Addendum

SPRINGS AT FREMAUX TOWN CENTER
SLIDELL, LA

PHILLIPS JOB NUMBER 1333104
ISSUE DATE 07/07/14
DRAWN BY/CHECKED BY ATL/DEB
DRAWING TITLE UNIT 2GC FLOOR PLAN, ELEVATIONS & DTLs.
SHEET NUMBER A4.2GC

UNIT 3GC
FLOOR PLAN,
ELEVATIONS & DTLs.
 SHEET NUMBER

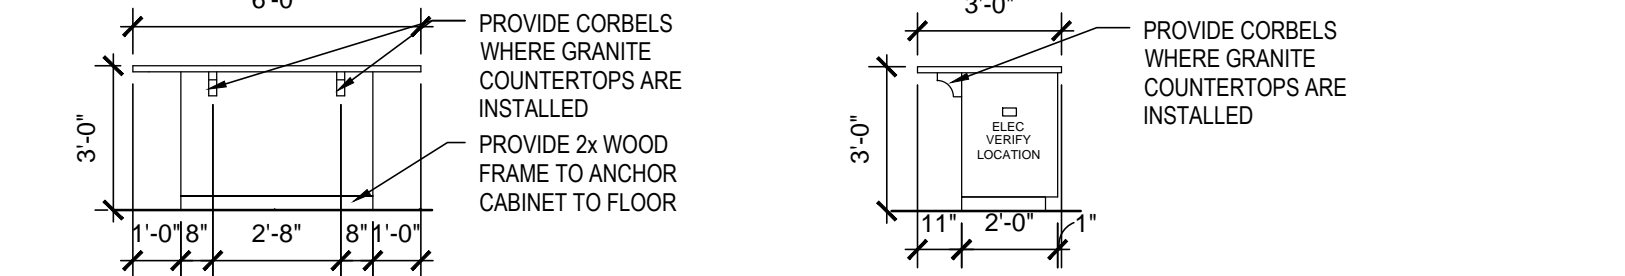
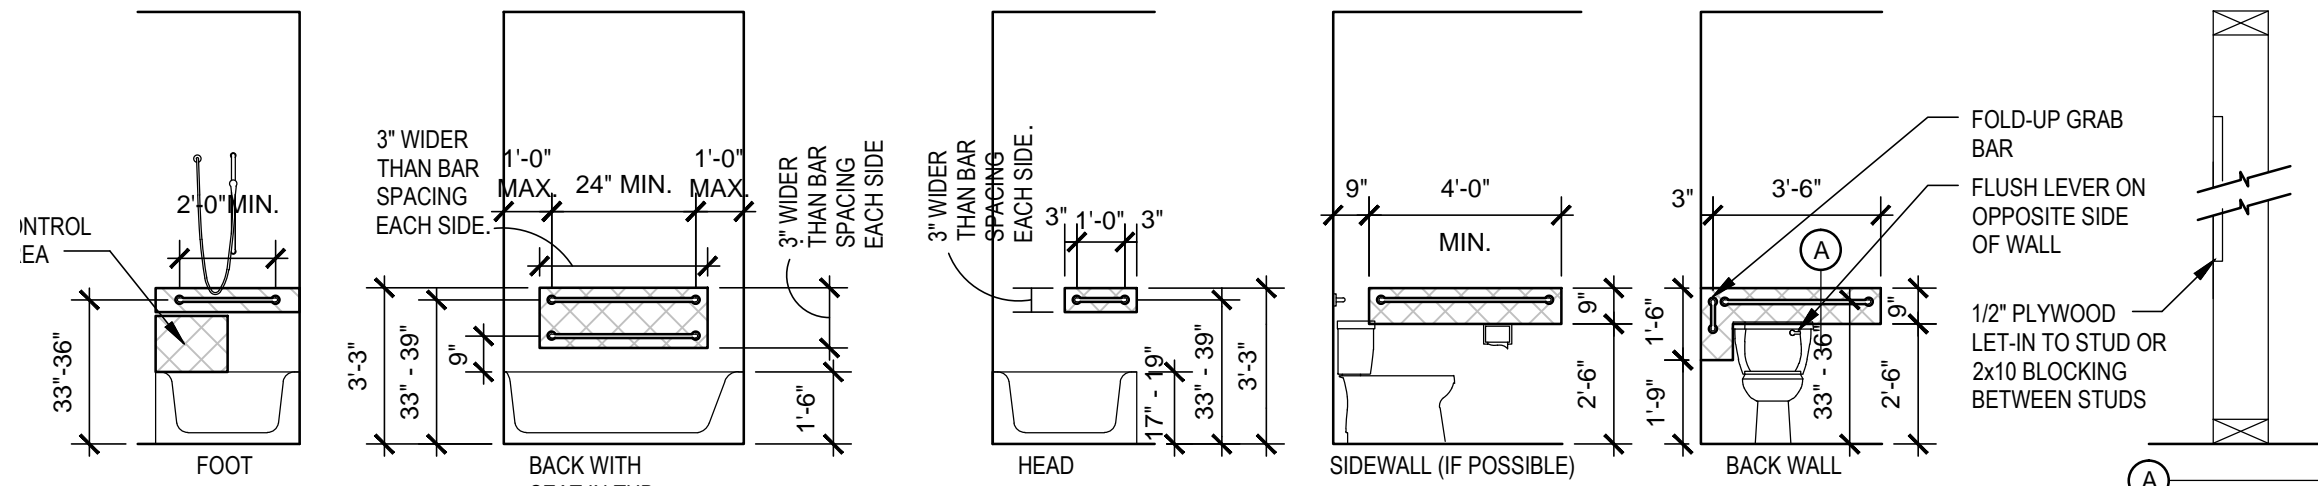
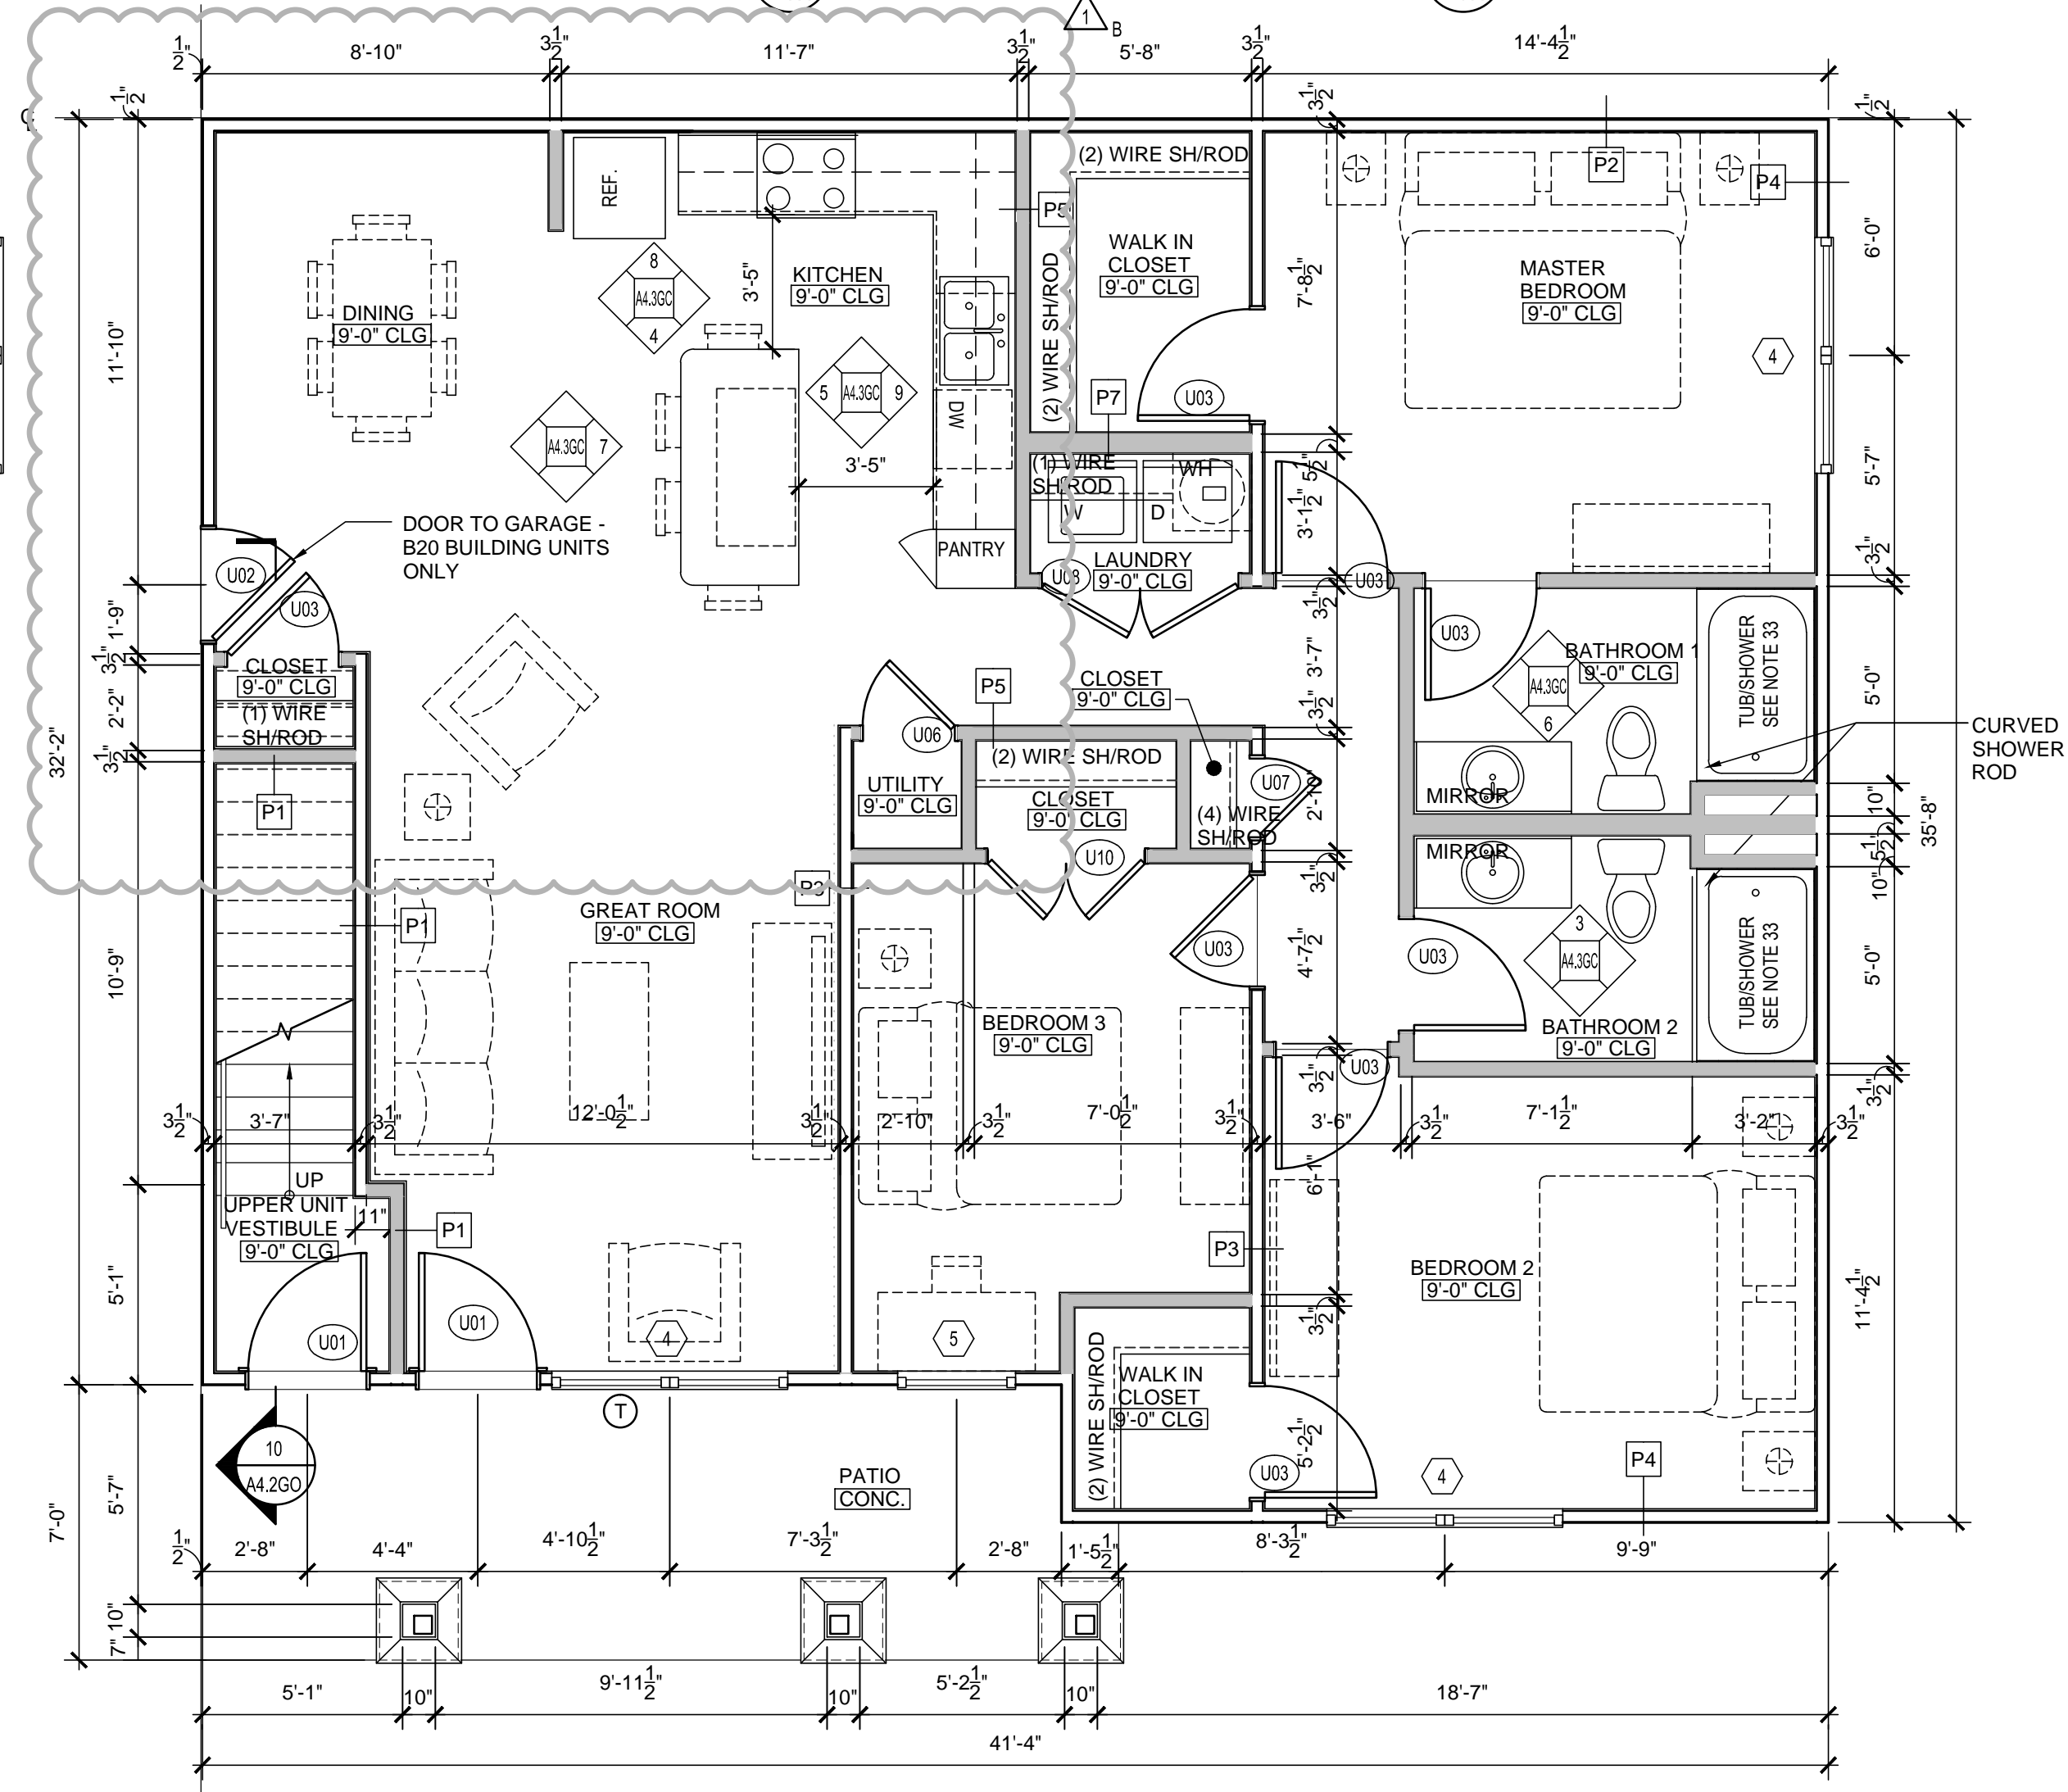
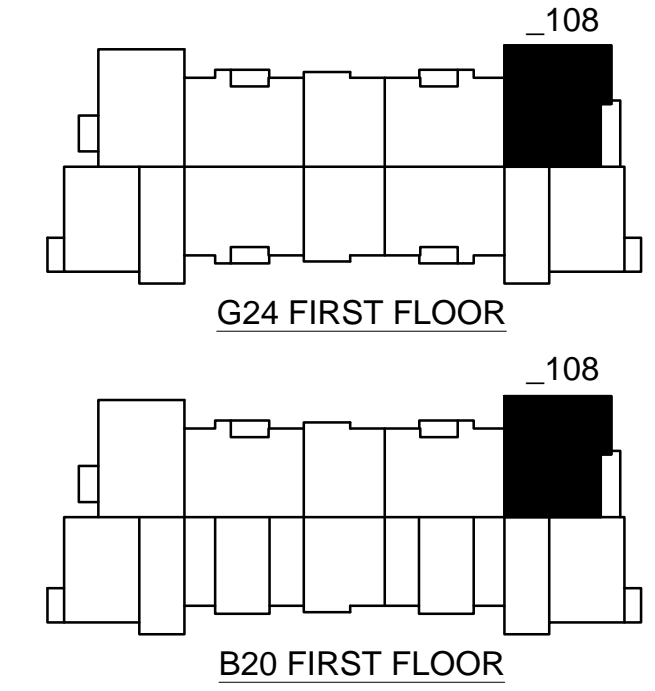
- REMOVED TILE BACKSPLASH AT CONCIERGE UNITS
- UPDATED KITCHEN AND DINING ROOM LAYOUT
- UPDATED KITCHEN ELEVATIONS TO COORDINATE W/ NEW KITCHEN LAYOUT
